CHANGE TYPE: Modification

602.2.1.8

Pipe and Duct Insulation Within Plenums

This excerpt is taken from *Significant Changes to the International Plumbing/Mechanical/Fuel Gas Codes, 2021 Edition*.

Pipe insulation

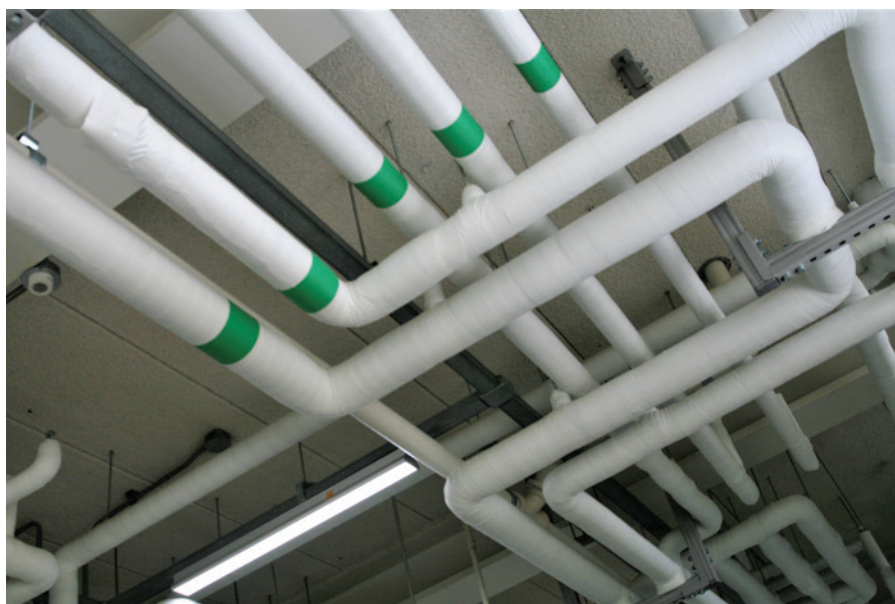
CHANGE SUMMARY: The revision addresses the practice of using pipe insulation materials to protect piping that does not meet the required fire performance requirements.

CHANGE SIGNIFICANCE: It is common for plastic piping to be installed in plenum spaces, such as above-ceiling return air plenums. Section 602.2.1 requires that materials installed within plenums be non-combustible or have a flame spread index of not more than 25 and a smoke-developed index of not more than 50 when tested in accordance with ASTM E84 or UL 723. Some plastic piping materials cannot meet the requirements of Section 602.2.1; therefore, if they are installed within a plenum, they must be protected by some material that does meet the fire performance requirements and that is listed for that application. Section 602.2.1 allows combustible piping to be “fully enclosed within materials listed and labeled for installation within a plenum and listed for the application.” The revised code text states that if pipe insulation is used as the enclosing material, the entire assembly of the pipe, the insulation and any coverings and adhesives must be tested as a composite assembly. Although there are insulation materials available that meet the fire performance requirements themselves, it is an unknown how the entire assembly will perform unless the entire assembly is tested. Without being tested as a composite assembly, it is possible that the protected piping could break down and degrade when exposed to heat, despite being protected by a pipe insulation material.

2021 CODE: 602.2.1.8 Pipe and duct insulation within plenums. Pipe and duct insulation contained within plenums, including insulation adhesives, shall have a flame spread index of not more than 25 and a smoke developed index of not more than 50 when tested in accordance with ASTM E84 or UL 723, using the specimen preparation and mounting procedures of ASTM E2231. Pipe and duct insulation shall not flame, glow, smolder or smoke when tested in accordance with ASTM C411 at the temperature to which they are exposed in service. The test temperature shall not fall below 250°F (121°C). Pipe and duct insulation shall be listed and labeled. Pipe and duct insulation shall not be used to reduce the maximum flame spread and smoke-developed indices except where the pipe or duct and its related insulation, coatings and adhesives are tested as a composite assembly in accordance with Section 602.2.1.7.
